AT89C51CC03

Silicon Errata and Data Sheet Clarifications

44-Lead Plastic Thin Quad Flatpack (PT) - 10x10x1.0 mm Body [TQFP]

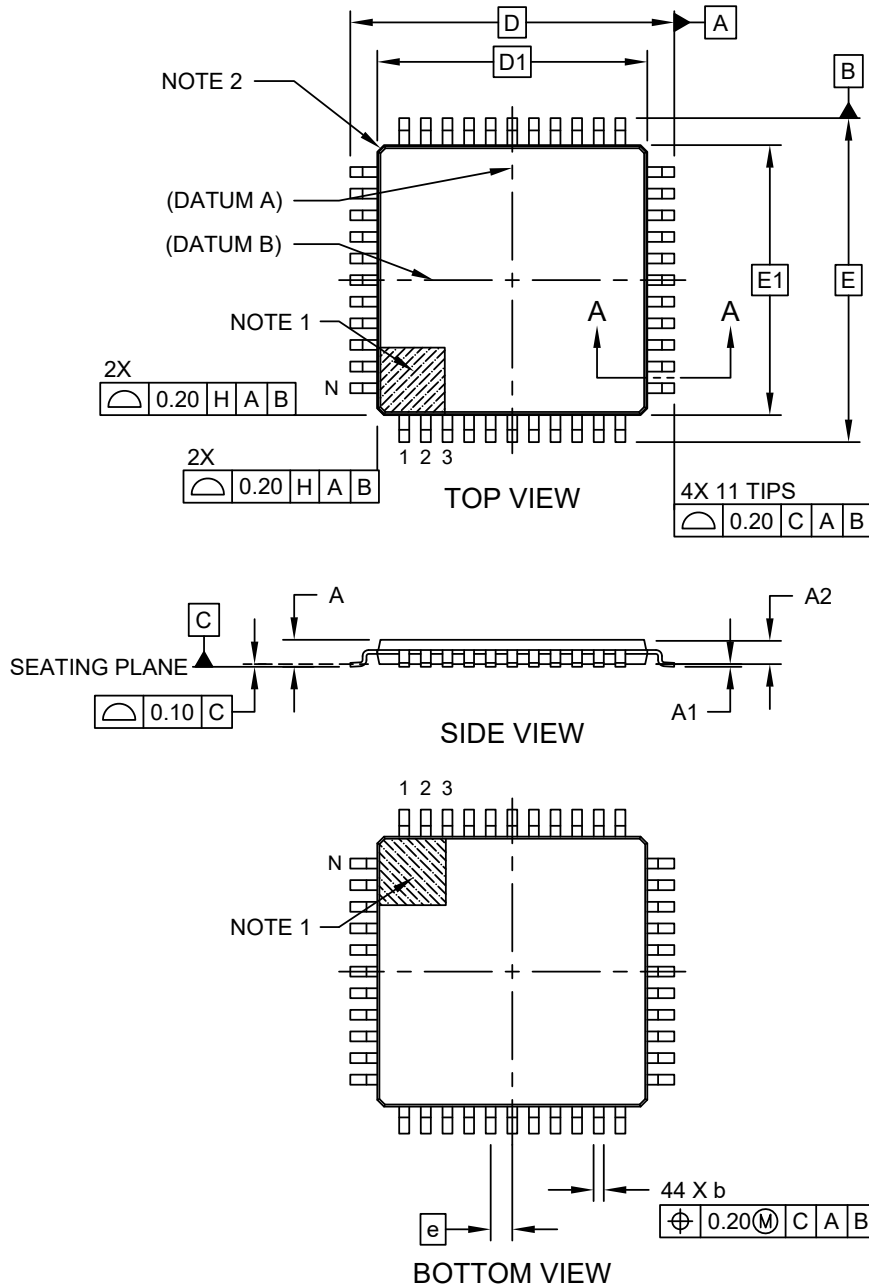
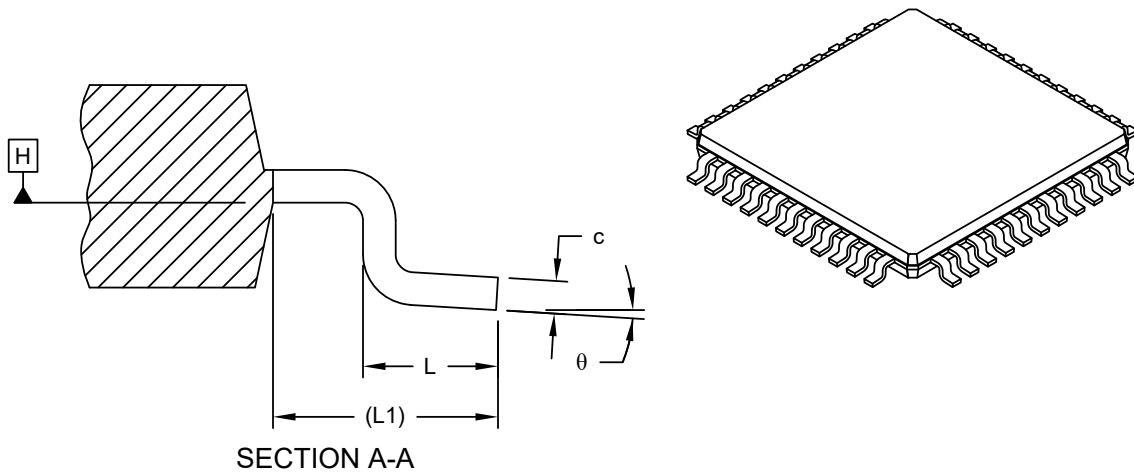
A clarification has been made to replace the VQFP package with a TQFP package.

A drop-in replaceable 44-lead TQFP with the same pinout, footprint, and based on the same die revision replaces the 44-lead VQFP package. There are no functional changes, hence all data sheet specifications are still valid for the replacement CPNs.

The TQFP package outline drawing is shown below.
